UNITED STATES ENVIRONMENTAL PROTECTION AGENCY
REGION 5
77 WEST JACKSON BOULEVARD
CHICAGO, IL 60604-3590

Subject: Review of Consolidated Groundwater Monitoring Report for Semi-Annual Monitoring Events June 2021 and November 2021 (2021 Groundwater Report) Southeast Rockford Groundwater Contamination Superfund Site

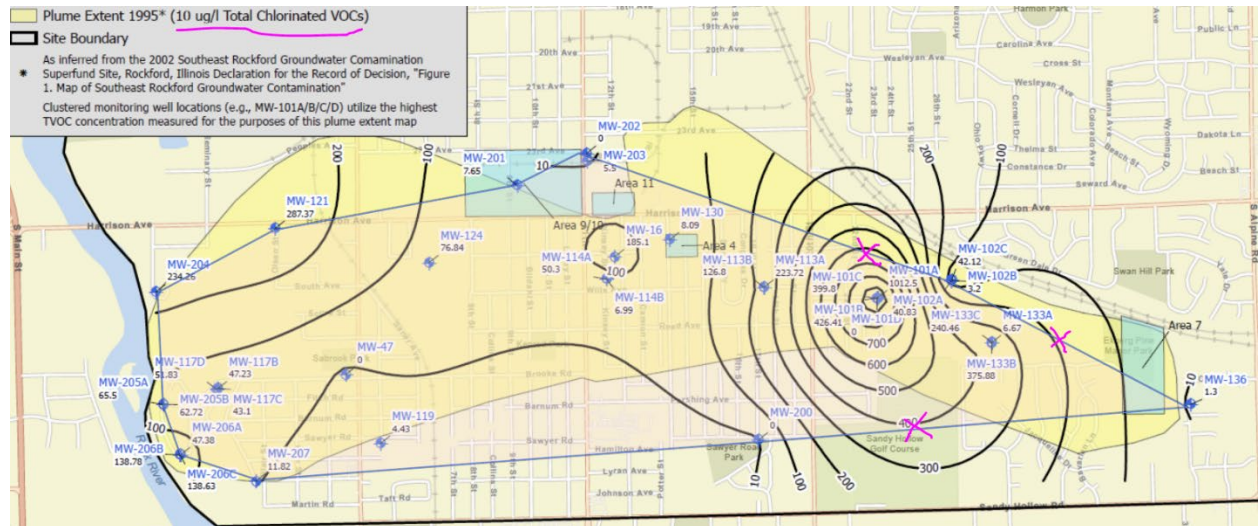
U.S. Environmental Protection Agency (EPA) has reviewed the above titled document issued March 17, 2022, and prepared by Nationwide Environmental Services, Inc. (NES) on behalf of the City of Rockford (City) for the Southeast Rockford Groundwater Contamination Superfund Site (SERGCSS) in Rockford, Illinois. EPA reviewed the responses to comments from Appendix C and the responses are satisfactory. Please note, the implementation of some of those responses warrant additional (or clarifying) comment and are detailed below (Comment #'s 2, 4, 5, 6, 9, 10, 12) in addition to new comments from the 2021 Groundwater Report.

EPA realizes the transformation of the OU2 Groundwater Report is an iterative process. In that vein, EPA is requiring a revision of the 2021 Groundwater Report (inclusive of a response to comment letter), incorporating the below comments, unless the comment specifically states that the specified modification shall be implemented in the next 2022 semi-annual groundwater monitoring report (and will be highlighted in yellow). If there are uncertainties or disagreements with any of the below comments please contact me so that we may discuss and agree on an appropriate path forward.

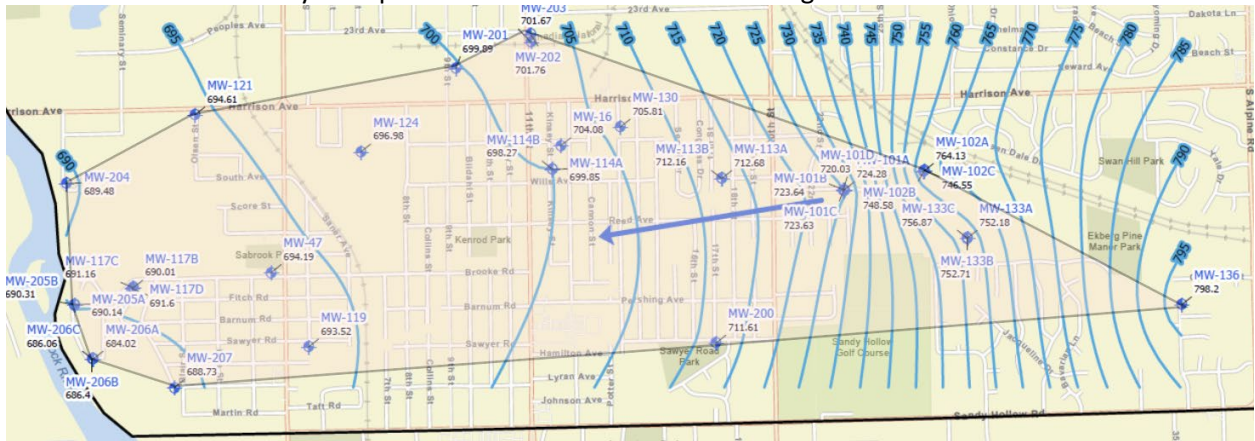
7. Potentiometric Contour Lines – Dash contours outside the data boundary (light red polygon below) where not constrained by data points. Include dashed line in the legend.
